**General Electric Company
Hudson River Project**

**REVIEW OF THE HUDSON RIVER PCBs
REASSESSMENT RI/FS PHASE 2 REPORT
VOLUME 2B -
PRELIMINARY MODEL CALIBRATION REPORT**

**Presented to the
U.S. Environmental Protection Agency, Region II**

February 5, 1997

Cesium-137 Calibration with Sedimentation Rate of 1.1 cm/yr
Without Groundwater Flow

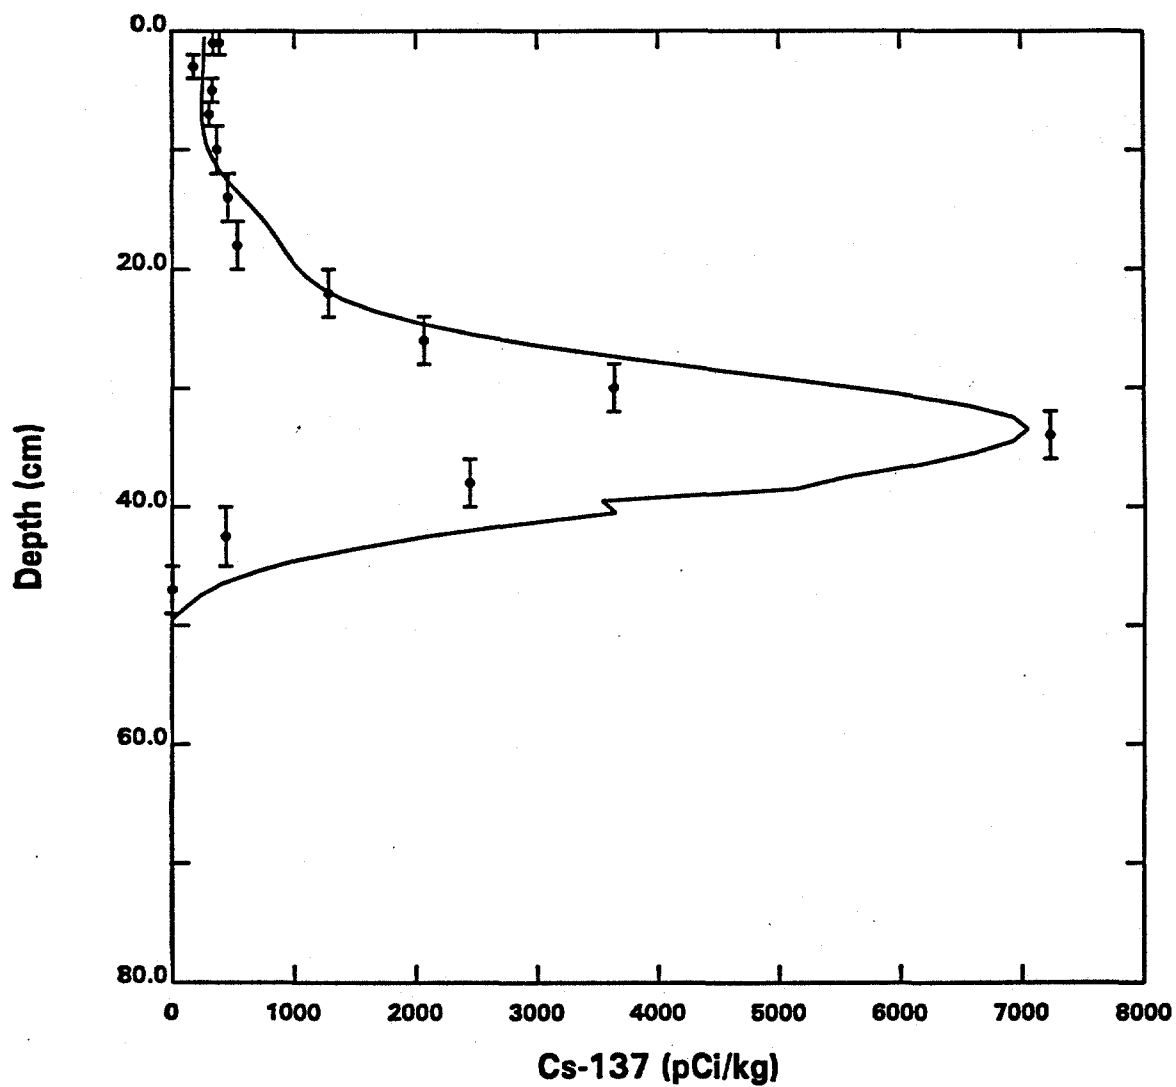
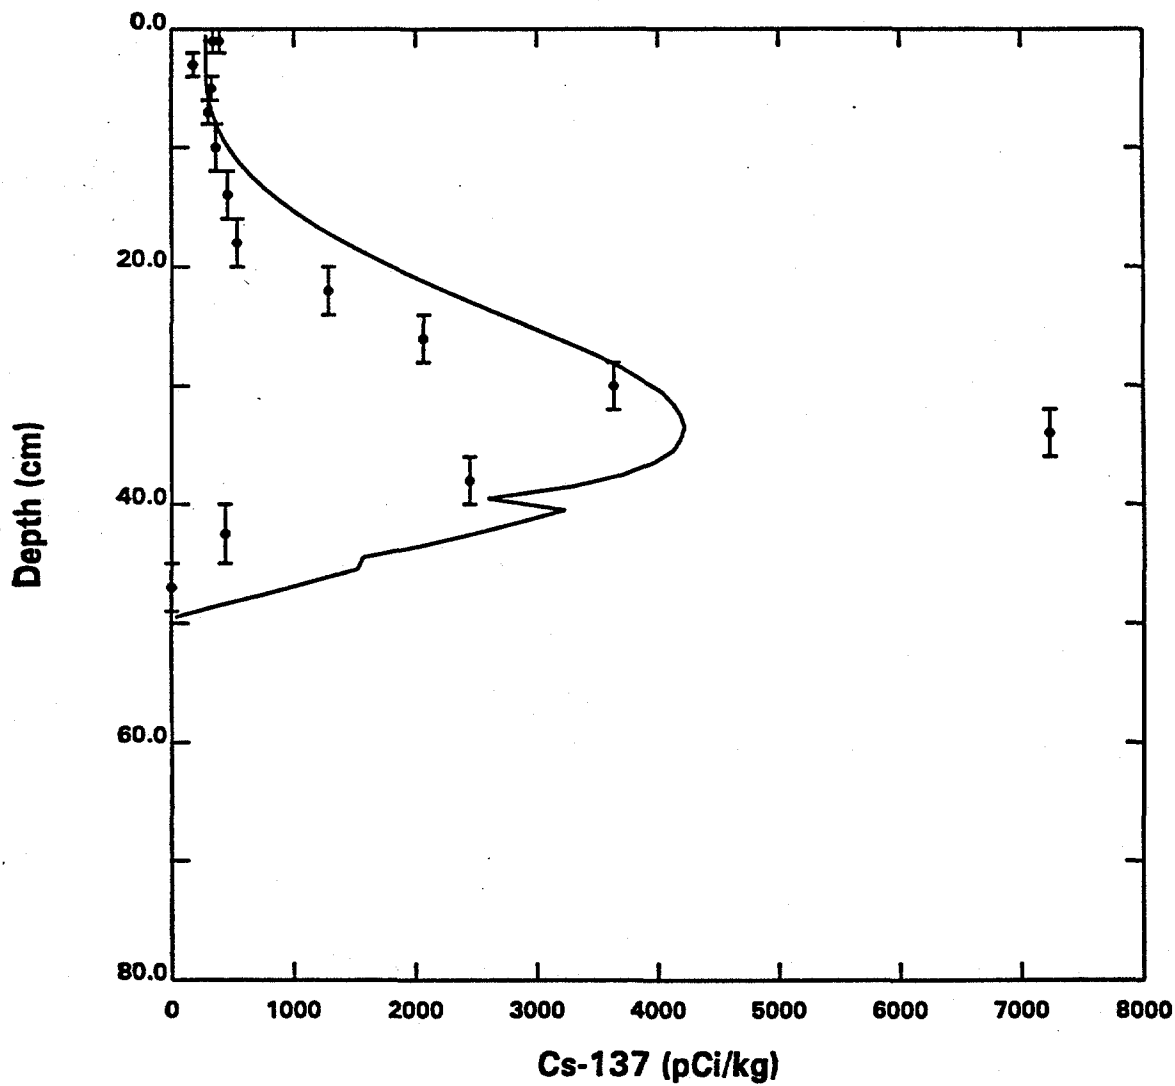
- The ground water inflow hypothesis is inconsistent with the radiotracer and PCB profiles in sediments from depositional areas

Figure 9-9
Comparison of Observed and Predicted Aroclor 1016 Concentrations in
Hudson River Largemouth Bass (Corrected to NYSDEC 1983 Quantitation Basis)

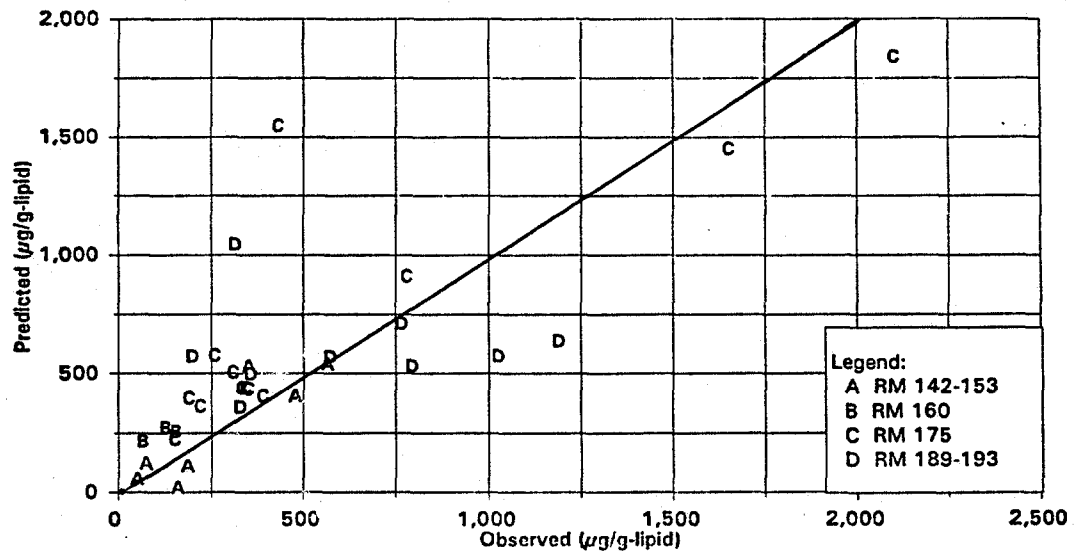
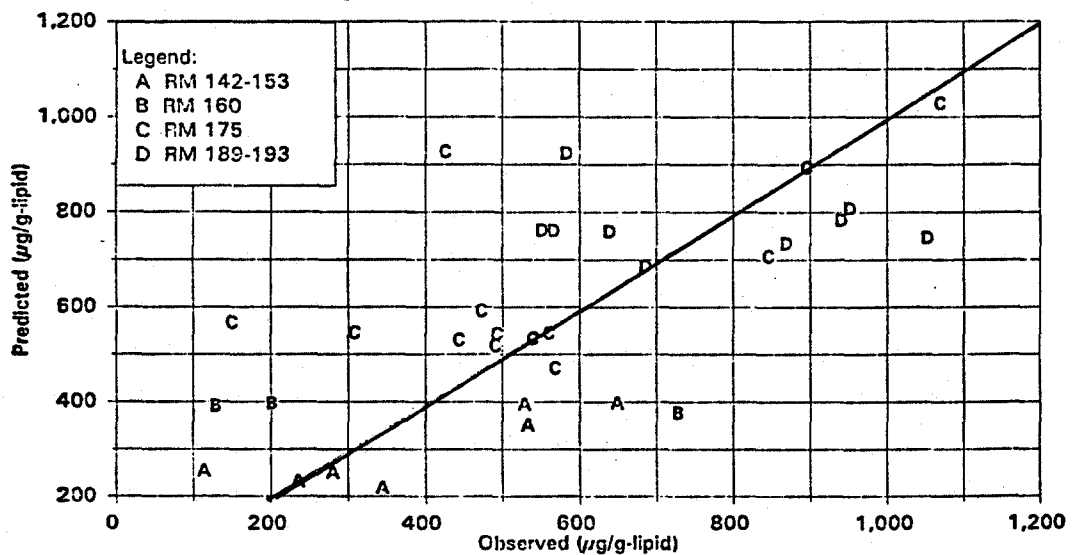
- Bivariate statistical model (BSM) and the probabilistic model (PM) assume steady-state conditions
- BSM over predicts PCBs at low water and sediment concentrations
- PM is circular, requiring the answer (i.e., variability of PCB levels among individual fish) to do the problem
- PM confuses variability and uncertainty
